<b>Title - Sujet</b> Marine Facility WaterSystem Upgrade	
<b>Solicitation No. - N° de l'invitation</b> F1700-204309/A	<b>Amendment No. - N° modif.</b> 009
<b>Client Reference No. - N° de référence du client</b> F1700-204309	<b>Date</b> 2020-10-23
<b>GETS Reference No. - N° de référence de SEAG</b> PW-SPWY-028-8811	
<b>File No. - N° de dossier</b> PWY-0-43048 (038)	<b>CCC No./N° CCC - FMS No./N° VME</b>
<b>Solicitation Closes - L'invitation prend fin</b> <b>at - à 02:00 PM</b> <b>on - le 2020-10-29</b>	<b>Time Zone</b> <b>Fuseau horaire</b> Pacific Daylight Saving Time PDT
<b>F.O.B. - F.A.B.</b> <b>Plant-Usine:</b> <input type="checkbox"/> <b>Destination:</b> <input checked="" type="checkbox"/> <b>Other-Autre:</b> <input type="checkbox"/>	
<b>Address Enquiries to: - Adresser toutes questions à:</b> Chiasson (PWY), Danielle	<b>Buyer Id - Id de l'acheteur</b> pwy038
<b>Telephone No. - N° de téléphone</b> (604) 349-7097 ( )	<b>FAX No. - N° de FAX</b> (604) 775-6633

Marine Facility Water System Upgrade  
Institute of Ocean Sciences, Sidney, BC  
Solicitation No: F1700-204309/A

The following changes in the tender documents are effective immediately. This addendum will form part of the

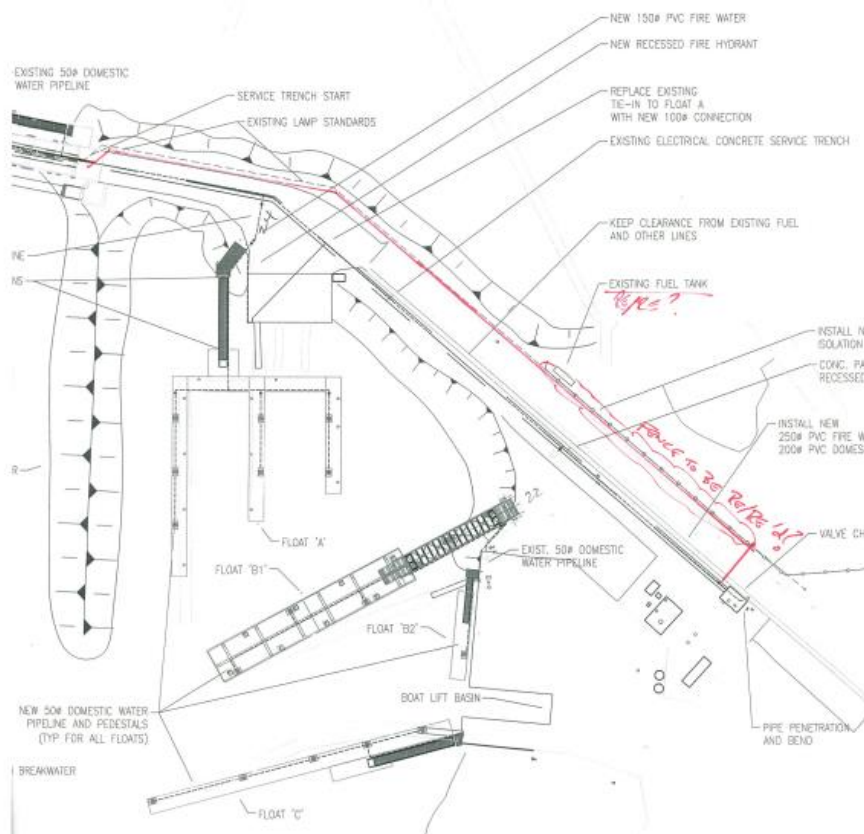
**Question 1:** I'm sorry to ask another question, but I feel I need some clarification on the recently posted addendum #8. Can you please see the sketch below and confirm if the red lines represent the intent of relocating the waterlines to the north side of the road? If this is the case, then the note 1 in addendum #6 with respect to no lamp standard and fence removal and replacement needs to be addressed. If the intent is to cross the road, then the fence will have to be removed and relocated. What about the fuel tank?

**Answer: Refer to Drawing C006 rev4 for pipe routing. Pipe is to be routed south of the road from the existing Valve Chamber to west of the second last light standard (from fixed wharf) as shown on the Drawing. After the second last light standard, the pipes can be routed north of the road by road crossing west of the second last light standard (see sketch below).**
